Re: Report under Section 179 (3) of the Planning and Development Act, 2000 as amended

The proposed development comprises the construction of 45 no. units and all associated site works at Lehenaghmore.

PROPOSED RESIDENTIAL DEVELOPMENT AT LEHENAGHMORE, CO. CORK

Drawing title			
HOUSE TYPE C3 - 2-BED TOWNHOUSE			
PLANS, ELEVATIONS, SECTION A-A & 3D RENDER			
Scale	Drawn	Checked	Date
1:100/200 @ A3	PC	EJG	07.06.23
Project No.	Drg. No.		Revision
20185	20185/P/155		P1
Information \ Comments Tender			
Planning Construction

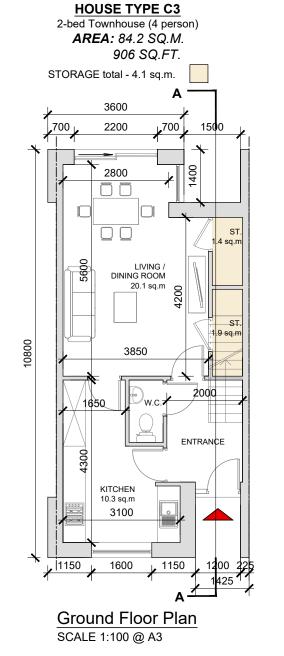
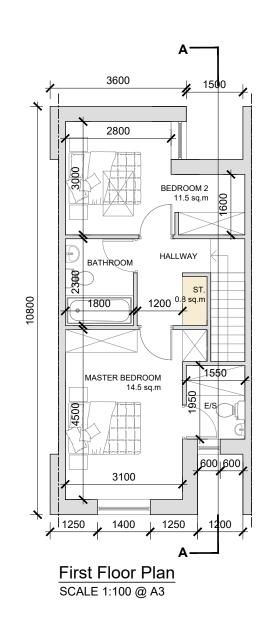
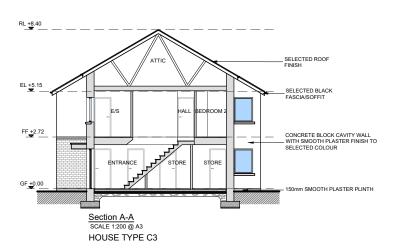
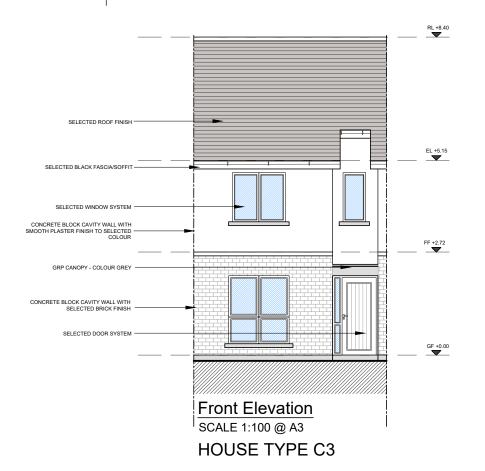
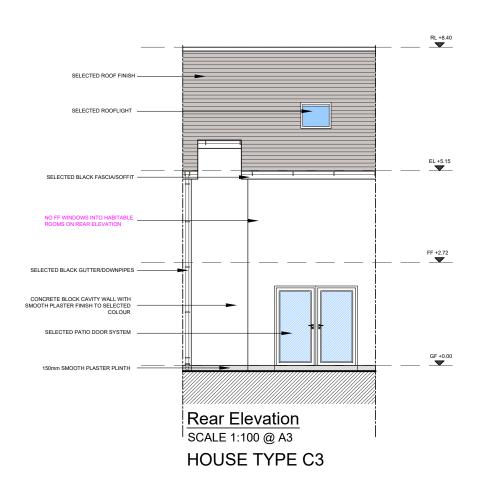
- 1. It was stated that there were concerns surrounding the potential impact on the residential amenity of the existing houses, with overlooking and overshadowing occurring as a result. It was suggested that the proposed housing will tower over existing houses which would hugely impact those houses in proximity and the neighbouring estate in general by blocking light from lower-level West Avenue and taking away their privacy. It was requested that elevation of the site should be reduced considerably and that some houses should be replaced by bungalows.

Taking on board the submissions of adjoining residents with regard to perceived concerns on overlooking, the City Council proposes an amendment to the design of the development to alter the rear elevation of property numbers 37-45 by re-aligning the upper floor rear-facing bedroom windows to prevent any perceived overlooking of adjacent private properties (revised elevation drawings - Drawing No's. 20185/P/003A, 20185/P/136 and 20185/P/004B at Appendix 2). This modification to the design will supplement all prior mitigation measures outlined above to provide additional assurance to the neighbouring properties with regard to the perceived concern of overlooking.
